## Product Change Notice (PCN)

**PCN Number:** PCN-0460116R-01

**Product(s) Affected:** TB004-508 series

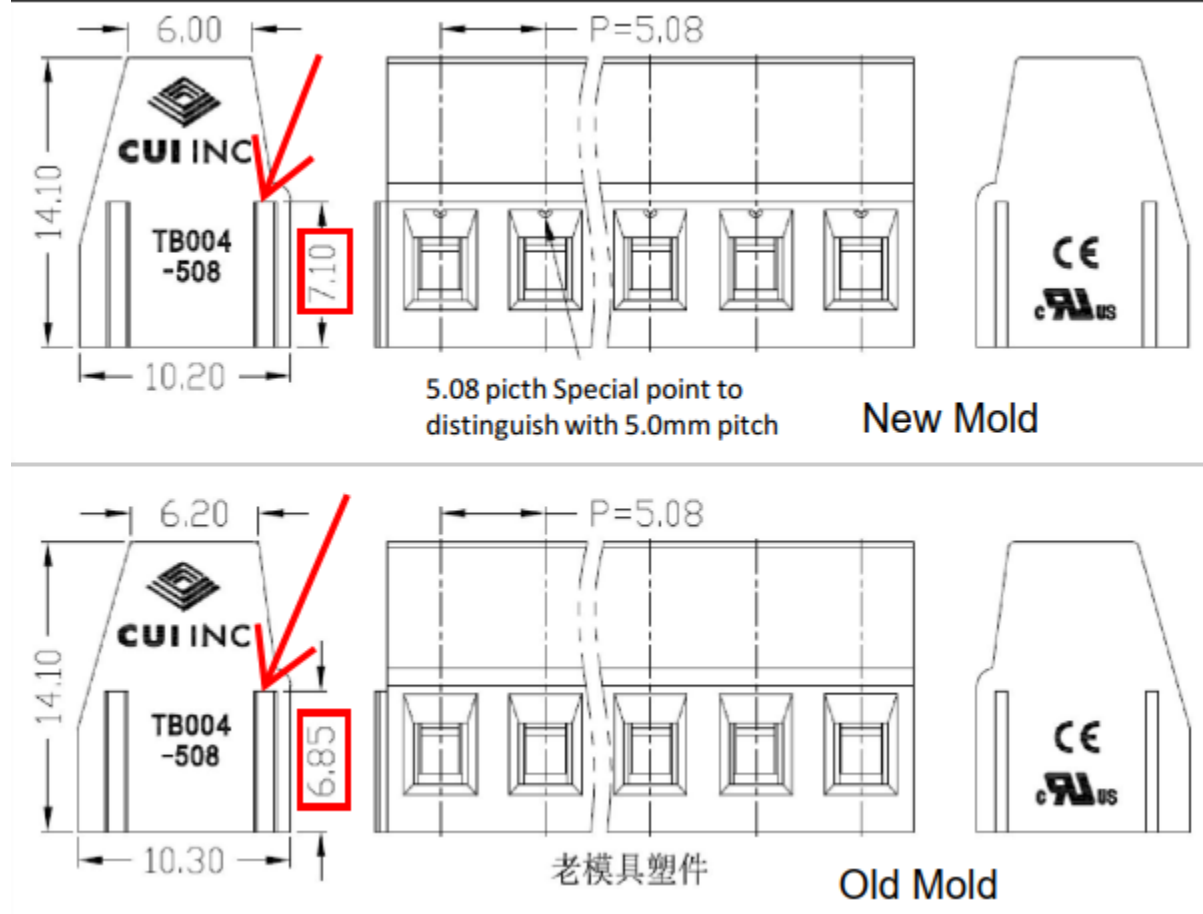
**Reason(s) for Change:** To promote the efficiency of automated assembly machine.

**Description of Change:** Adjusting slot height from 6.85mm to 7.1mm.
